Ref: 2023.03002

**RE: ENVIRONMENTAL AUTHORITY AMENDMENT RESPONSE TO INFORMATION REQUEST
NOTICE – DUGALD RIVER MINE**

Appendix A – Response to Information Request

Figure 3: DRM Clean Water Diversions and Drainage Systems

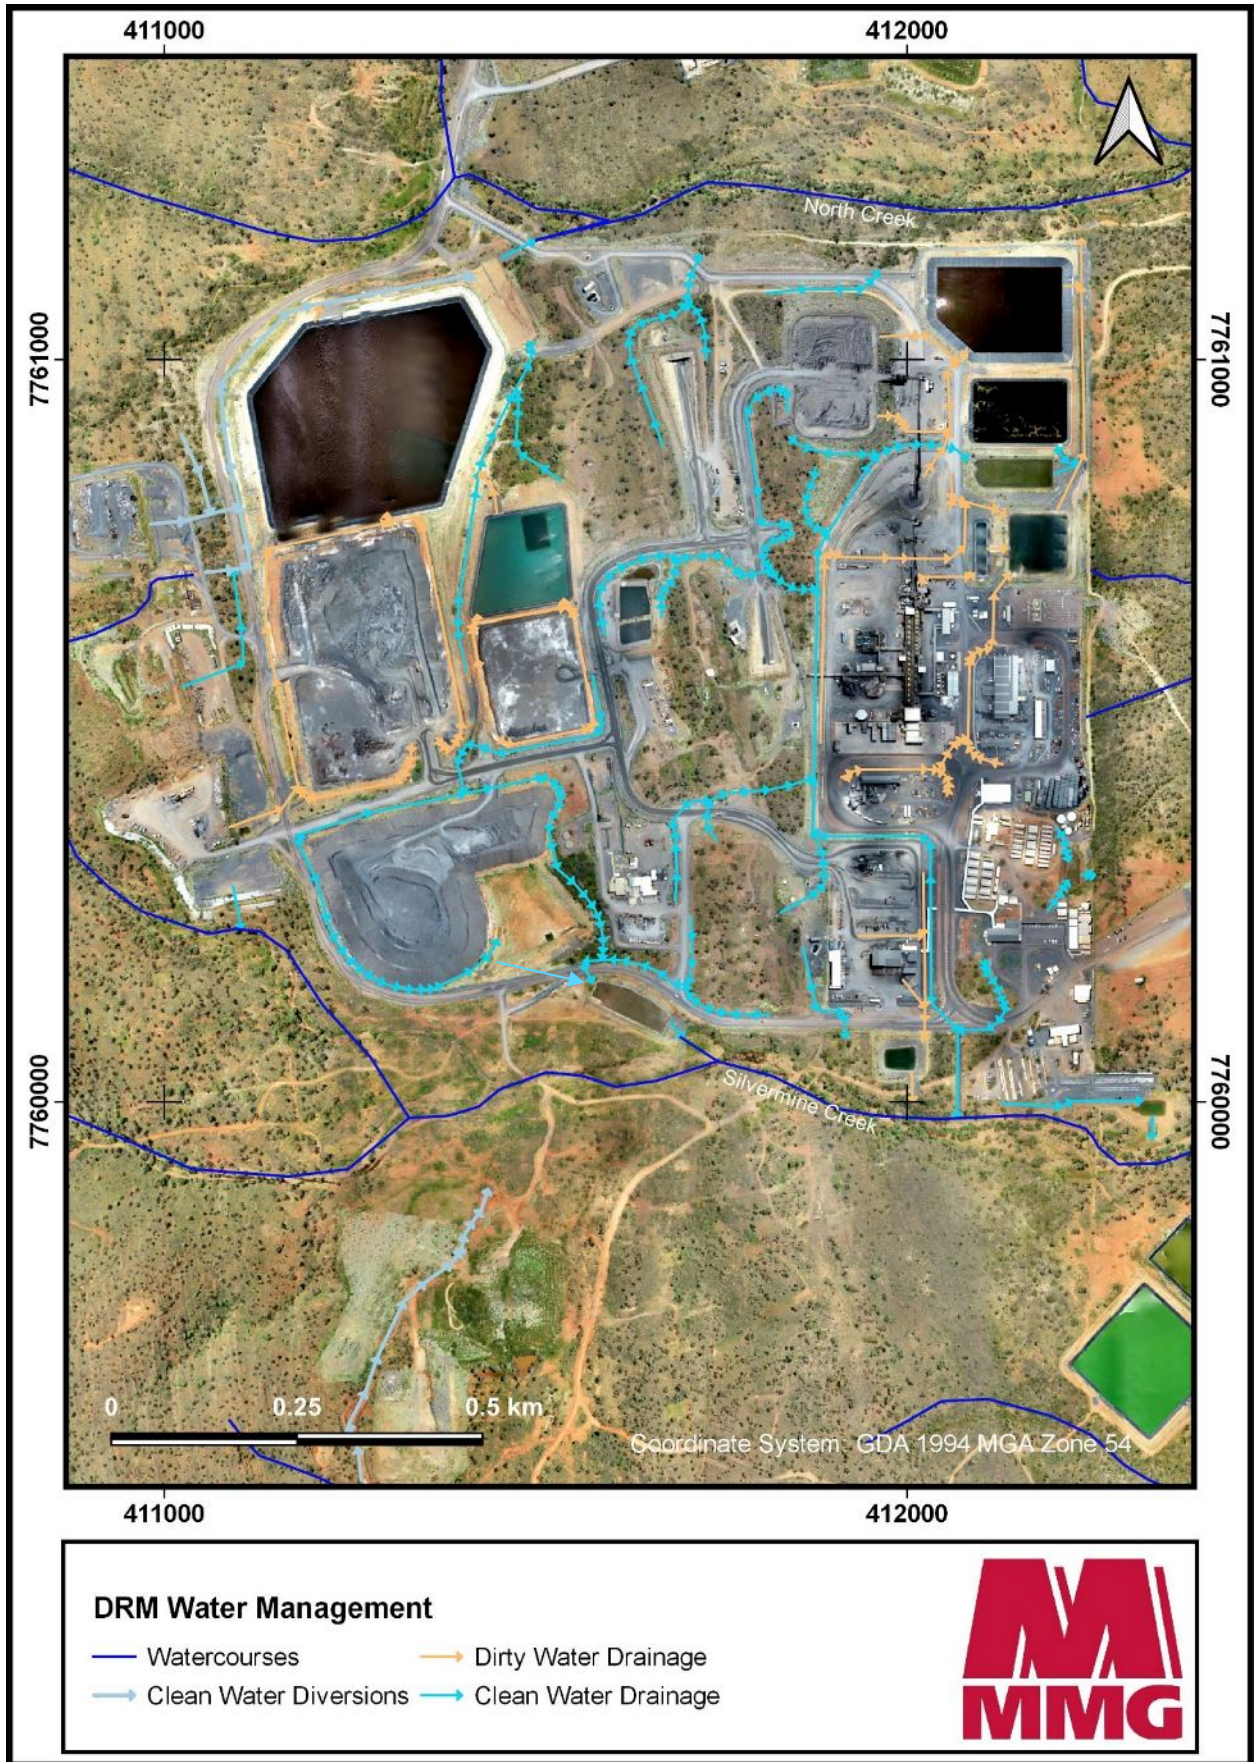
12	<p><u>Water management</u> Section 4.2.7.1.3. of the reports states diversion bunds will be erected upslope from disturbed areas and direct runoff into sediment basins and dams. These sediment dams or basins will be constructed to capture sediment and contaminants for treatment or retention. No further information is provided, and Appendix J (Erosion and sediment control plan) has not been attached.</p>	<p>Provide additional information regarding the proposed diversion bunds and sediments dams/basins. This information is required to understand the diversion of water around the site as a result of the proposed activity. This information includes:</p> <ul style="list-style-type: none"> • Details regarding the diversion of water as a result of the proposed activity. • Detailed information and mapping of all proposed diversion bunds, sediment basins and dams. Clarify if the proposed sediment basins or dams will receive clean stormwater runoff or, as suggested, it is expected to be receive contaminants. If so, further information is required regarding the potential impacts, proposed treatment, and management of this water. <p>Provide Appendix J.</p>	<p>No additional diversions, bunds or sediment basins are deemed necessary for the Project. The text within the Supporting Information Report has been amended for clarity.</p> <p>Erosion controls will consist of:</p> <ul style="list-style-type: none"> • Conducting construction works during the dry season where possible (April – November); • Minimising all surface disturbance. Large vegetation will be selectively cleared for the laydowns, STP, vent shaft and groundwater infrastructure to maintain as much groundcover as possible and stabilise soils; • Stabilisation of exposed soils as soon as practical. Hardstands will be constructed for the turbine pads as soon as practicable after topsoil is removed to prevent long term exposure and minimise erosion; 	<p>Section 4.2.7.3 Appendix O</p>
